RE: Response to Comments, Bennoc Area NPDES OIL00159 Application for American Energy Corporation in Belmont County, Ohio

Response to OEPA Comments from Bruce Goff and Eric Nygaard Dated 8/21/12, 8/15/12, 7/20/12, 7/13/12, and 7/11/12 Bennoc NPDES Permit Application OIL00159

Hydro-Chemical Analysis of Waste Water Discharge and Anti-Degradation Assessment: American Energy Corporation's Bennoc Coarse Coal Refuse Area Ponds 001 and 002

Wheel treatment system – pictures provided by www.chemstream.com

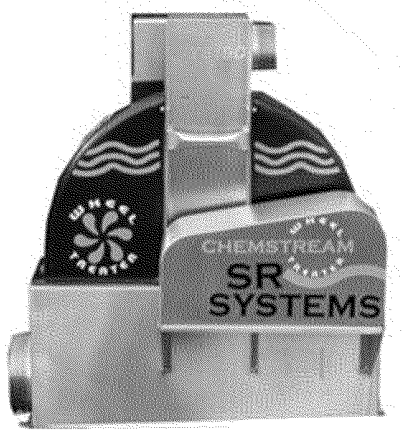
Comment: Do you happen to have any photos of the treatment ponds, the outlet structures, the chemical feed equipment and the discharge drainage ways (outlet ditches) you can share?

Response: We do not have any pictures of the proposed treatment ponds and their structures. However, we do have a picture (below) of the proposed wheel treatment system.
